NEI 12-04, Revision 0

**GUIDELINES FOR
10 CFR 72.48
IMPLEMENTATION**

August 2012

Nuclear Energy Institute

Figure 1
10 CFR 72.48 Process for Licensees and CoC Holders

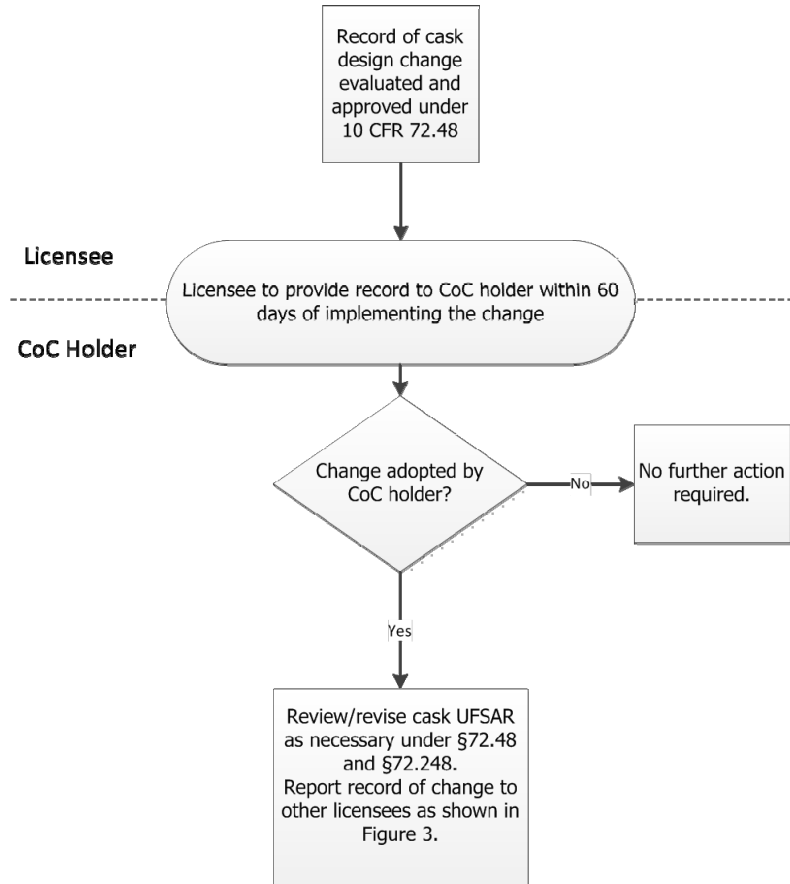
Comment [NRC118]: Delete the bullet showing 72.7, 72.56, and 72.244 in the bubble next to the first/top decision diamond in Figure 1. If the proposed change does not affect the ISFSI/cask, it is not clear why any of these procedures would be applied.

Comment [NRC119]: Add 72.7 to this bubble and in the bubble next to the 'Change to the ISFSI license...' decision diamond. The 72.7 process could be applicable to the 'yes' situation for these two decision diamonds.

Figure 2
General or Specific Licensee
60-Day Reports to CoC Holder

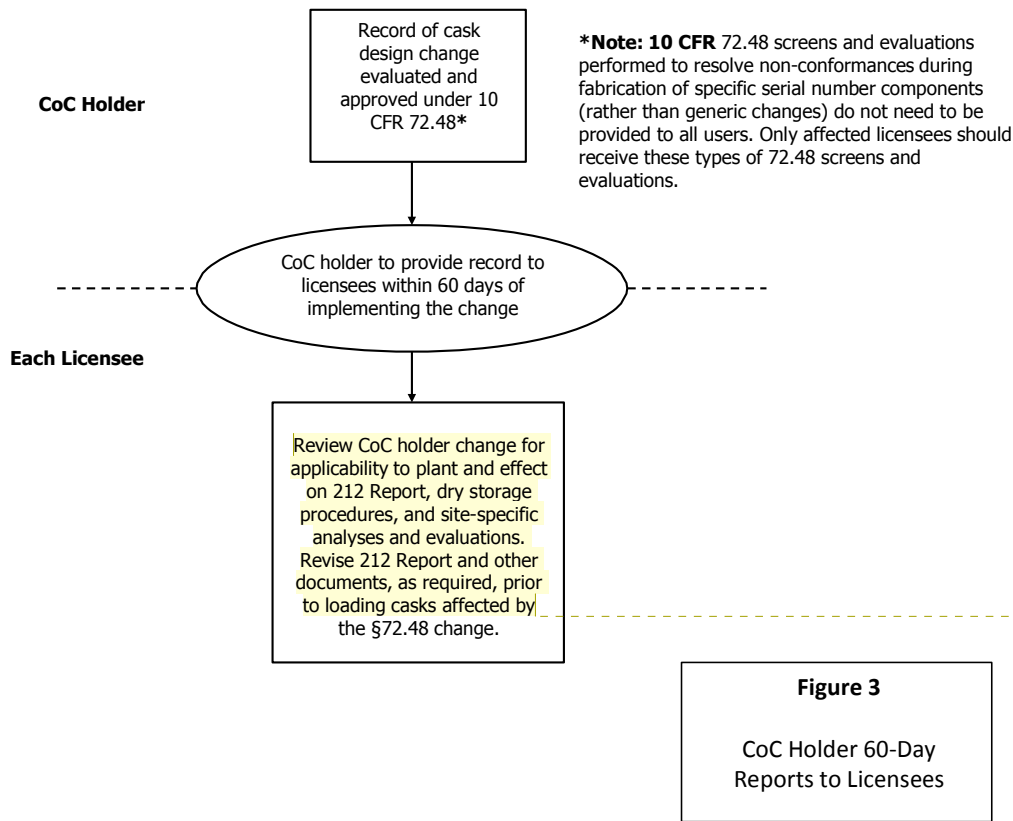
Comment [NRC120]: Is it not clear that licensees need to adopt changes made by CoC holders. Also, general licensees must evaluate modifications to their 72.212 Reports, etc. per 72.48. Figure 3 should be consistent with these two points.

Suggest replacing this box and its text with something like the figure inserted below/on the following page.
